SYDNEY NORTH PLANNING PANEL

Panel Reference	PPSNH - 107
DA Number	LDA2020/199
LGA	City of Ryde
Proposed Development	Demolition of existing structures and construction of a mixed use development comprising four buildings ranging in height between 6 and 7 storeys with 3 basement levels for 419 car parking spaces. The development will be comprised of 133 residential apartments, a boarding house with 162 rooms and 3591m ² of commercial floor space.
Street Address	1 - 20 Railway Road & 50 Constitution Road Meadowbank
Applicant/Owner	Applicant: Sasco Development P/L Owners: Liv-Better (Australia) P/L Shepherds Bay Holding P/L Kiu Foong P/L
Date of DA lodgement	12 June 2020
Total number of Submissions Number of Unique Objections	- 136 submissions received + 1 petition containing 5 signatures. - 67 of the submissions were unique objections. - Out of the 136 submissions – four were in support of the proposal.
Recommendation	Refusal
Regional Development Criteria (Schedule 7 of the SEPP (State and Regional Development) 2011	General Development over \$30 Million Cost of works: \$86,092,808.00

Report prepared by	Sandra McCarry Senior Town Planner
Report date	24 June 2021

Figure 20: Boarding House high light in blue.

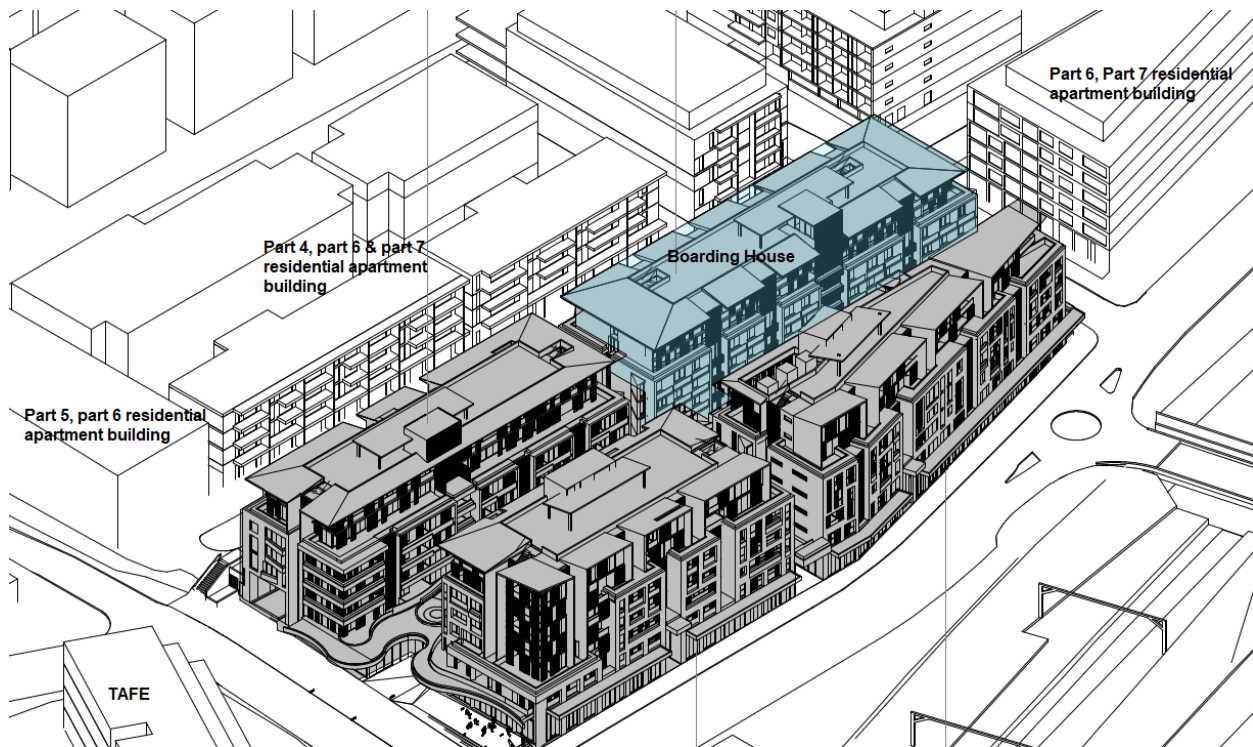
The site is located within the Shepherd's Bay, Meadowbank locality, an area that is undergoing significant redevelopment. The subject site is surrounded by recently constructed four (4) to seven (7) storey residential apartment buildings within the vicinity of the site. Plus, construction is currently under way for redevelopment of Meadowbank TAFE to a new Multi-trades and Digital Technology Hub, as detailed earlier in this report.

Figure 23: View from the sun at 9am.
Rough location of apartments mentioned above, circled where it will only get direct sunlight from 9am until just part 10am.

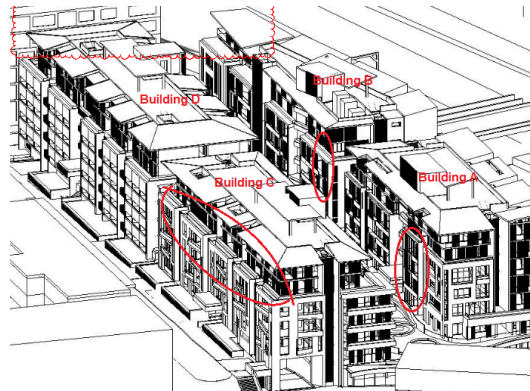
However, Council's Urban Designer states that "The information related to solar access shown on Drawing D503 is incorrect. The following east-facing units are indicated on Drawing D503 to be capable of receiving a minimum of two-hour direct sunlight on the 21st June from 9am to 3pm.

- Building A - Units A1-207, A1-307 and A1-407
- Building B – Units C1-408 and A1-505
- Building C - Units B1-406, C1-407, A1-408 and B1-409.

However, based on the views from the sun on Drawing D410, they will receive direct sunlight from 9am until just past 10am. It suggests that they will fail to meet the ADG's two-hour minimum solar access requirements. If these nine units are excluded from the calculation, the proposal will only have 84 (or 63%) out of the 133 proposed units which meet the ADG's solar access requirements."

Figure 27: Height blanket showing areas of exceedance against the two prescribed height for the site (18.5m in red and 21.5m in blue). Aerial view from the north western end of the site, at the corner of Railway Road and Constitution Road.

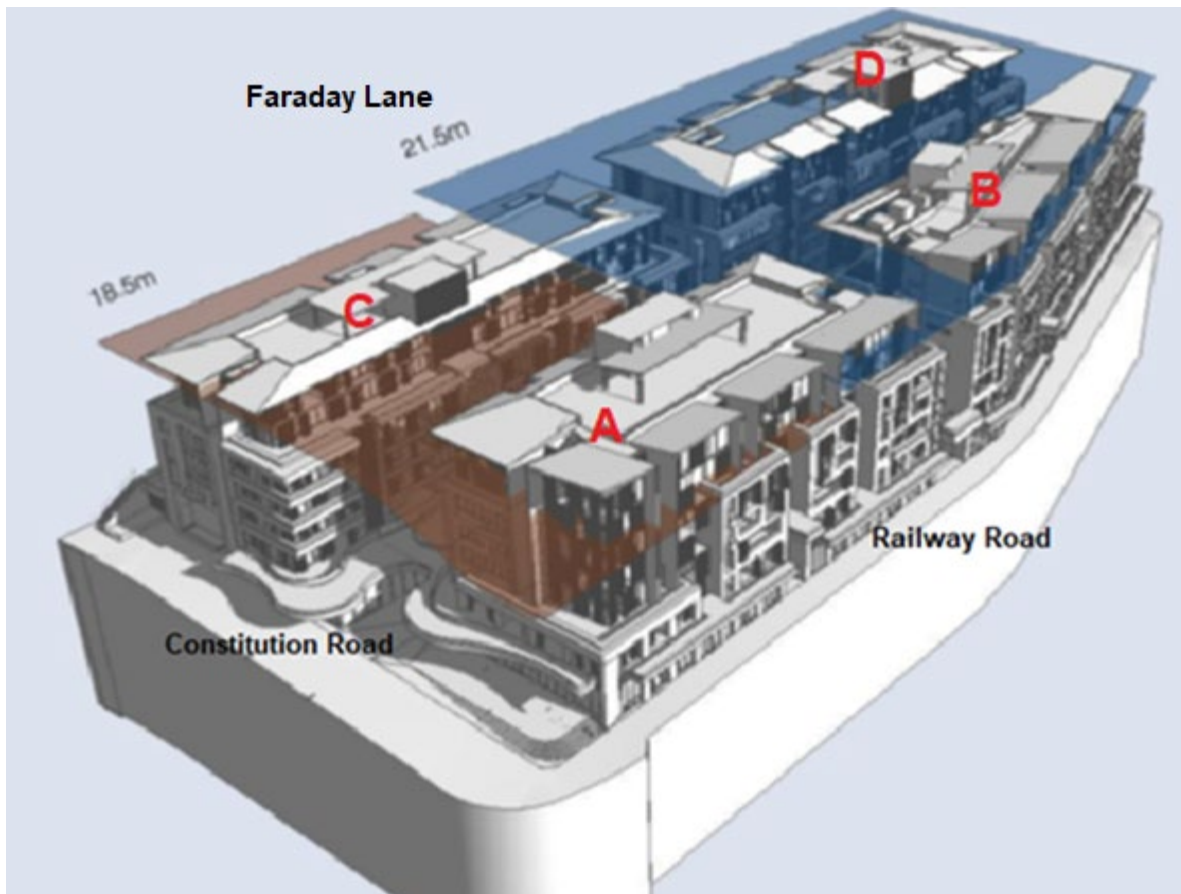
Building	Maximum Permitted Building Height under Ryde LEP 2014	Proposed Maximum Height (m)	Maximum Exceedance
A	18.5m (northern portion) 21.5 (southern portion)	25.8m	7.3m (39%)
B	21.5m	26.4m	4.9m (23%)
C	18.5m (northern portion) 21.5 (southern portion)	24.56m	6.06m (33%)
D	21.5m	25.87m	4.37m (20%)

Figure 33: The extent of height exceedance is more than just lift overruns and shade structure in Building A. The height exceedance is more than one storey and is habitable floor area visible from a public domain.

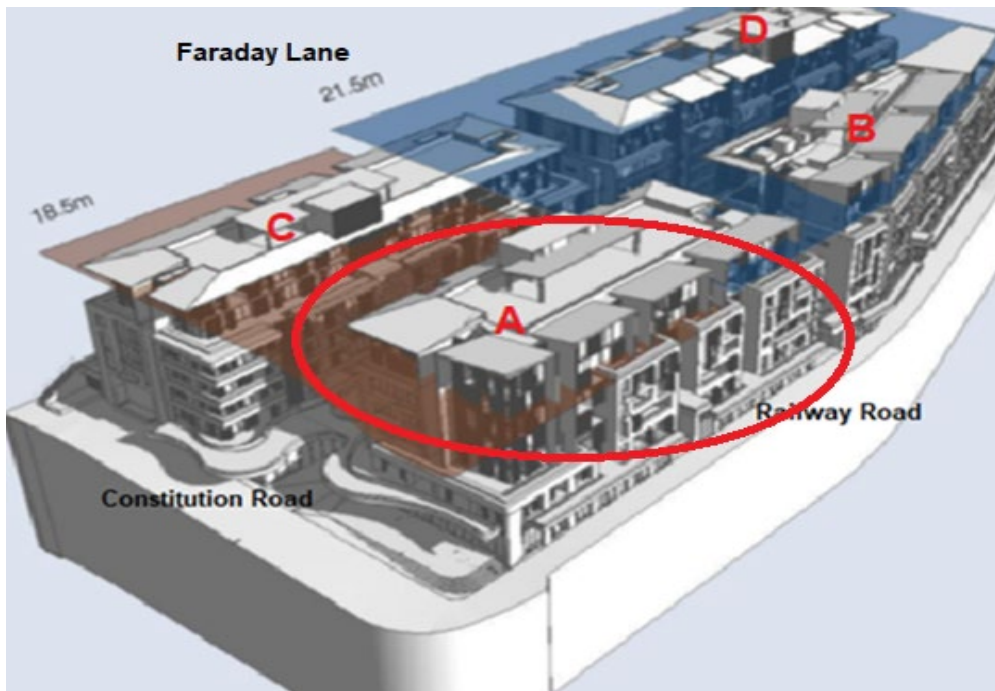
Council do not disagree that the immediate surrounding development to the south and east at 21-24 Railway Road and 3-13 Angas Street, respectively are 6 to 7 storeys however these developments generally complies with the maximum height, albeit minor variation of lift overruns or the upper portion of the top floor, with the building stepping down to follow the topography. 3-13 Angas Street which is the site opposite in Faraday Lane is part 4, part 6 & part 7 storey and have the two height zone, 21.5 and 18.5m across their site. Their development has been designed so that upper storey of the building does not extend right across the building, hence complying with the maximum height of 18.5m at the northern end of the site.

Council do not agree that a large portion of the building height non compliances relates to lift overruns and shade structures of the rooftop communal open spaces. A large proportion of the non compliance at the north western end of Building A is a storey above the height limit and is habitable floor space visible from the public domain as illustrated in **Figure 33**. This height variation adds to visual bulk when viewed from properties opposite and is not in keeping with the desired future character for this end of Railway Road.

Figure 34: Shadow diagrams of the proposed development to the development opposite in Faraday Lane.

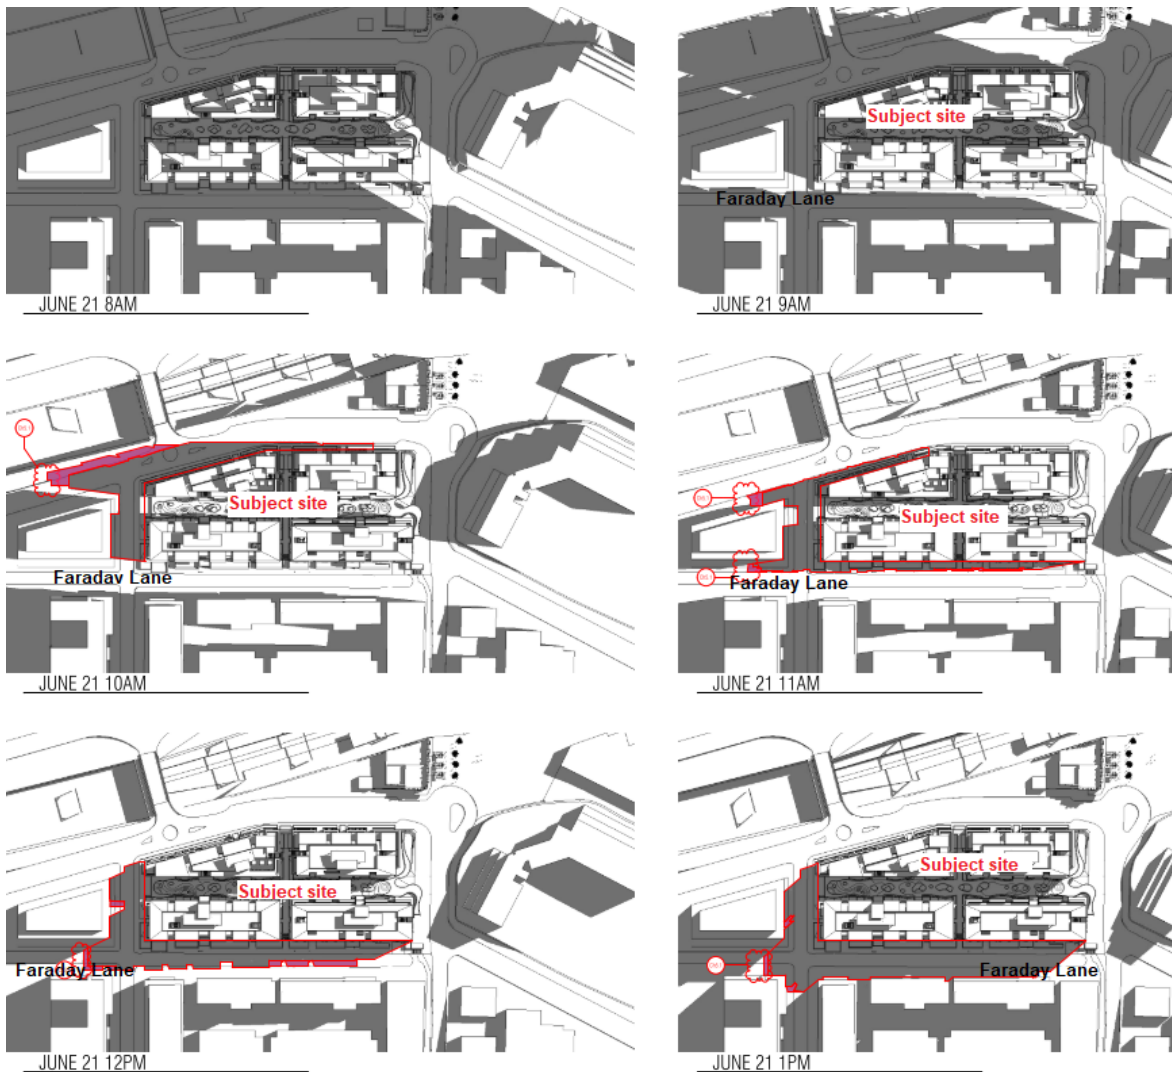
The apartment opposite in Faraday Lane will receive the morning sun, as shown in the diagram below. The proposed development will not start to cast a shadow to the apartments opposite until 1pm onwards, thereby receiving the morning sun.

Due to the orientation of the land, there will be overshadowing impact to Faraday Lane, which is avoidable. This forms reason for refusal of the application.
